METROPOLITAN GOVERNMENT OF NASHVILLE AND DAVIDSON COUNTY

STAFF RECOMMENDATION 1906 Fifth Avenue North July 16, 2014

Application: New construction-addition; New construction-outbuilding; Setback determination; Demolition-outbuildings and non-contributing addition

Description of Project: The applicant proposes construction of an addition to the side and rear of the existing building and construction of a new outbuilding. Demolition is proposed for a non-contributing addition and two existing accessory buildings. As the existing house is inside the minimum side setback and the proposed addition will encroach into the setback as well, a setback determination is requested from five feet (5') to four feet (4') for the right side of the addition.

SITE PLAN

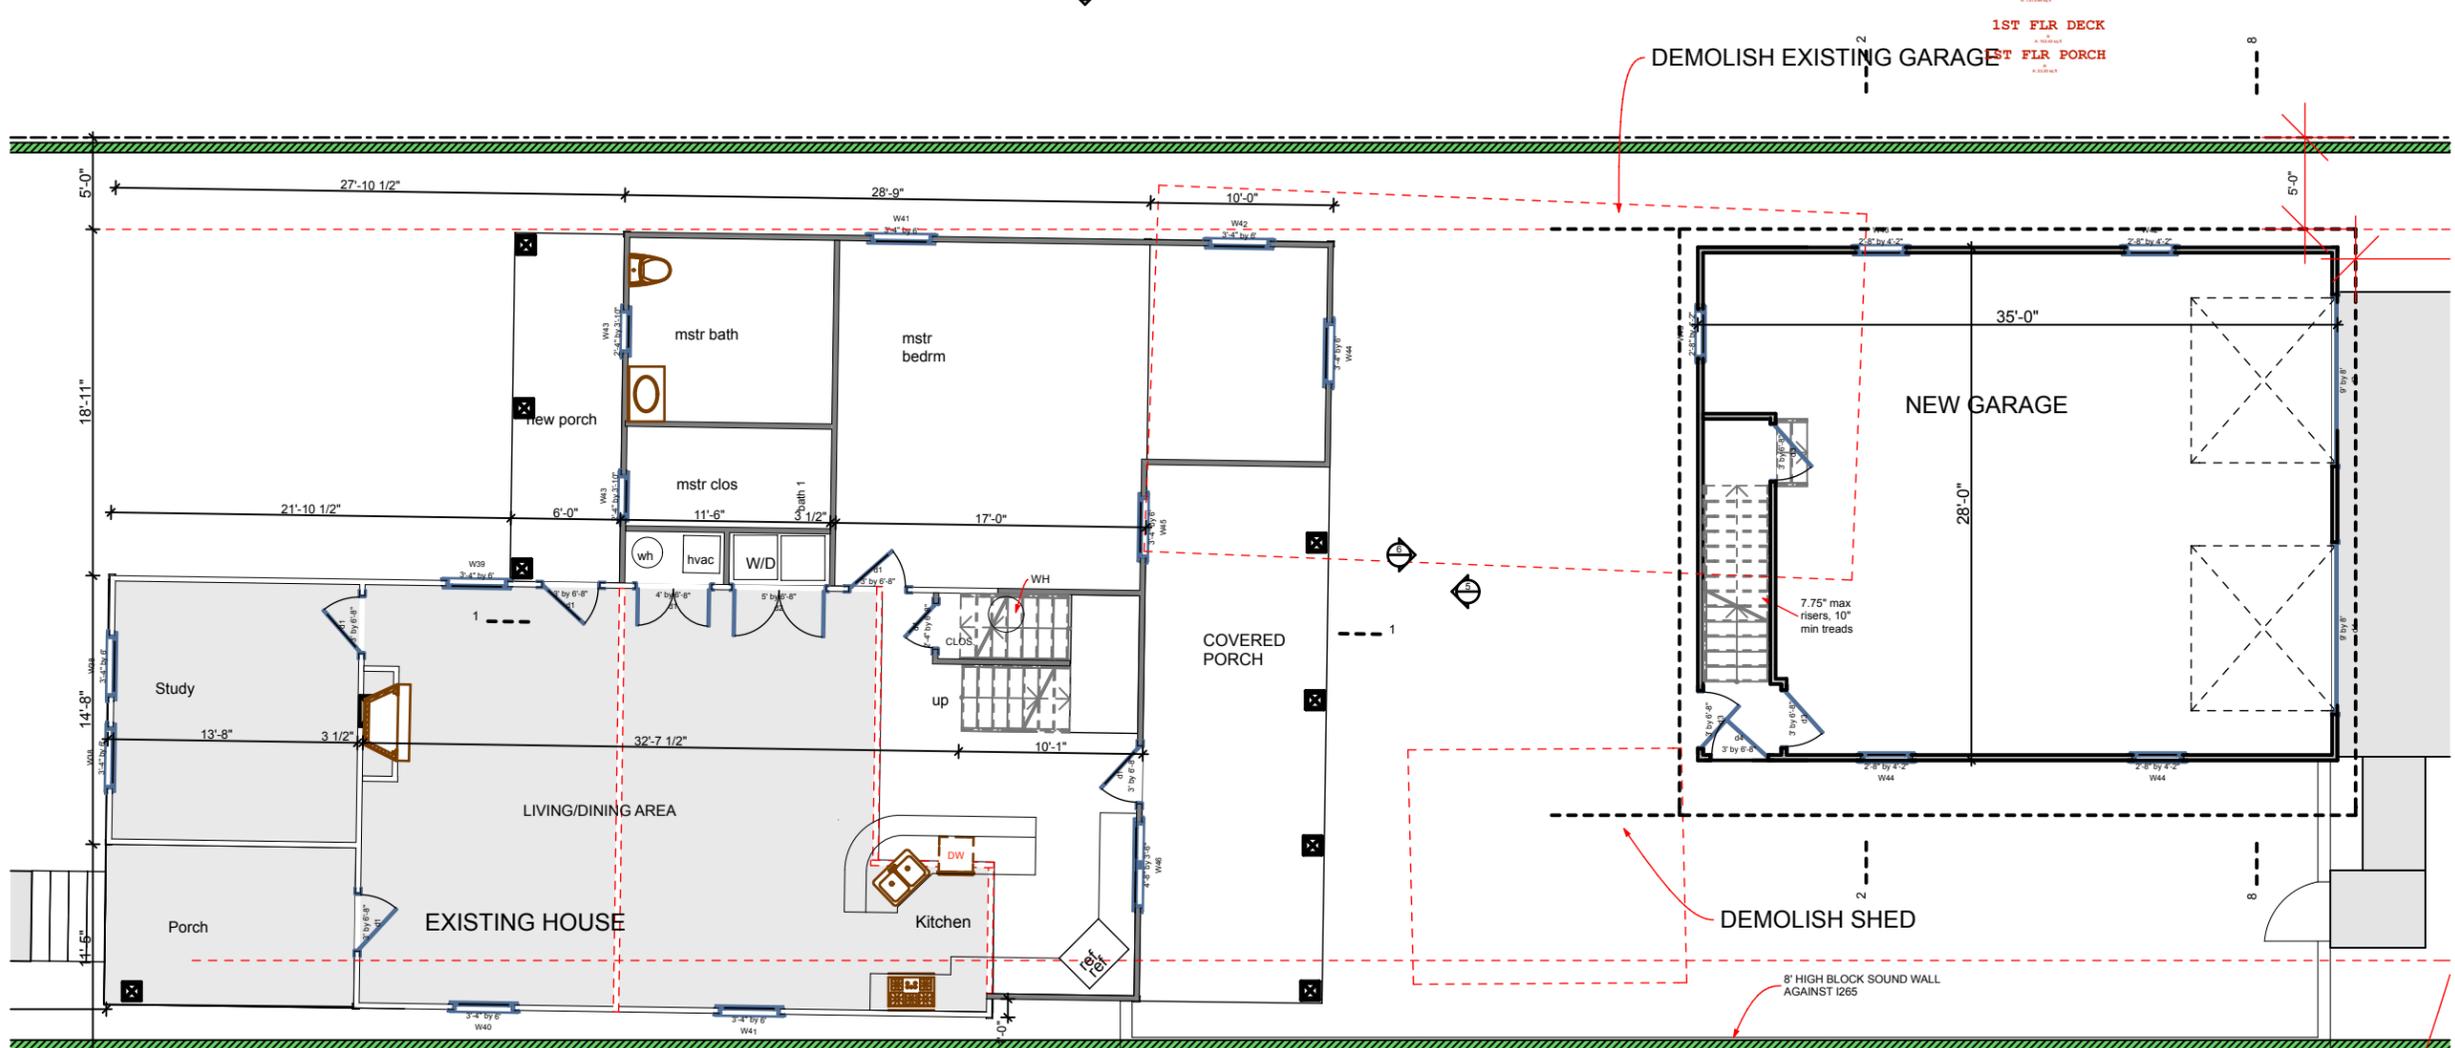
Setback & Rhythm of Spacing: The addition will be five feet (5') from the left side property line and seventy-five feet (75') from the rear, meeting setback requirements of five feet (5') and twenty feet (20') respectively. As the house itself is only two feet (2') from the right side property line, the addition will be four feet (4') inside the side setback, instead of the required five feet (5'). The applicant requests a setback determination for the right side. Staff finds the proposed setback to be appropriate, as the existing house does not meet the base zoning setback, and the addition will be inset from it.

1 RIGHT ELEVATION

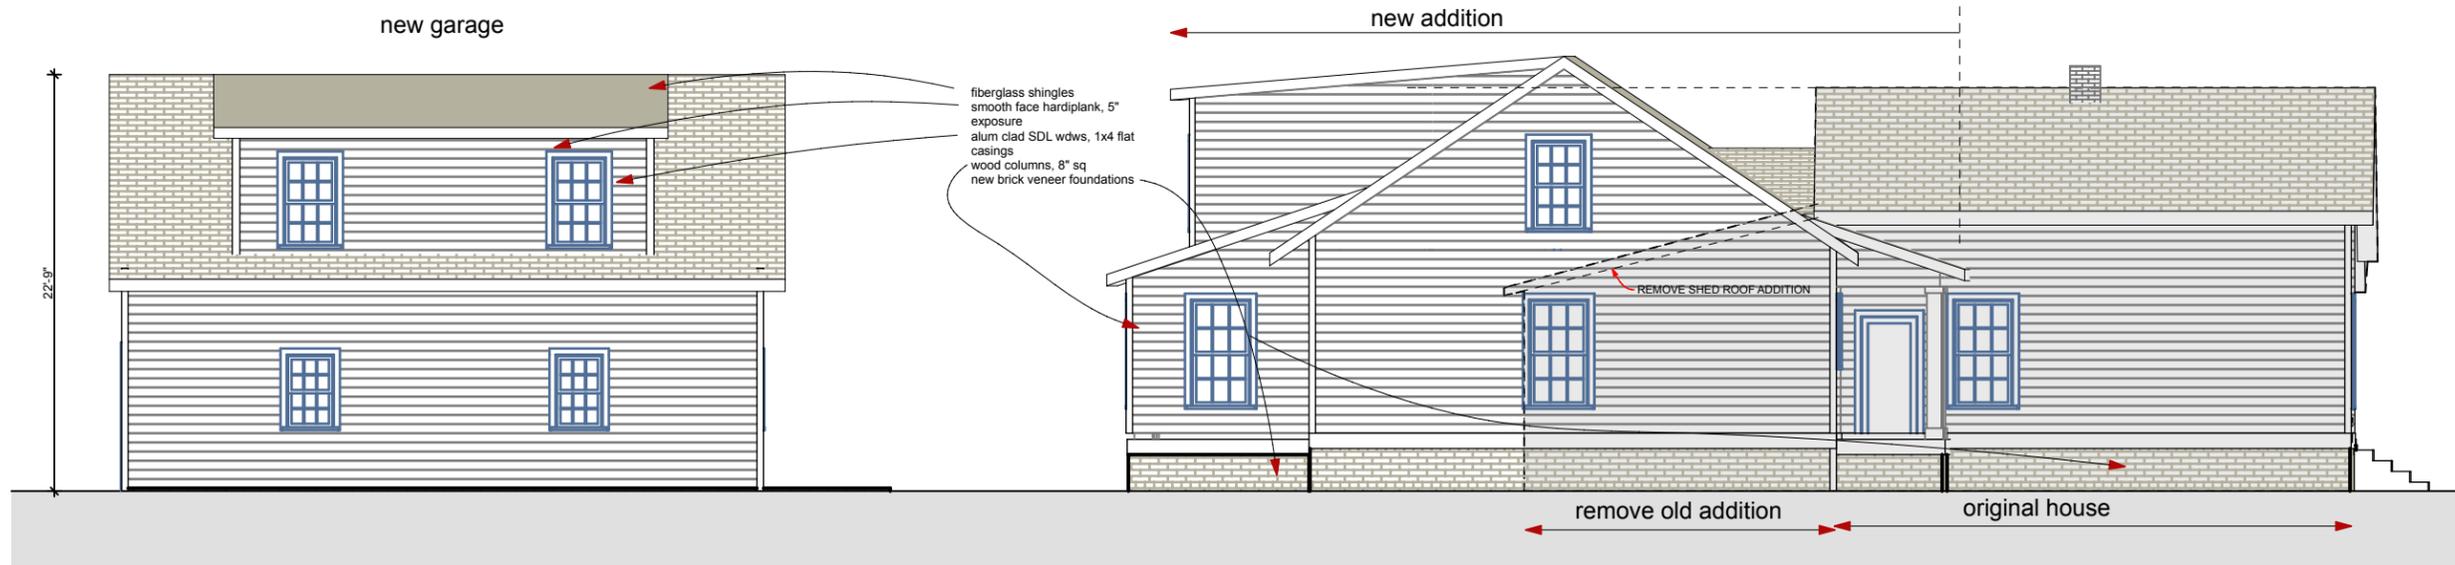
Proportion and Rhythm of Openings: The right elevation indicates a second door on the house's front porch is to be removed; this would not be an appropriate change to the historic house. Staff requests no changes to the window and door openings on the existing house were indicated on the plans. The windows on the proposed addition are all generally twice as tall as they are wide, meeting the historic proportions of openings. The largest expanse of wall space without a window or door opening is ten feet (10') toward the rear of the side facades. With the condition that no changes are made to the openings of the existing house, Staff finds the project's proportion and rhythm of openings to meet Section III.G.

- Staff have final review of the selection of windows, doors, garage doors, and materials for the porches, trim, and fences;
- HVAC and other utilities be located at the rear of the house, or on a side façade beyond the midpoint of the house; and,
- No changes shall be made to the openings of the existing house.
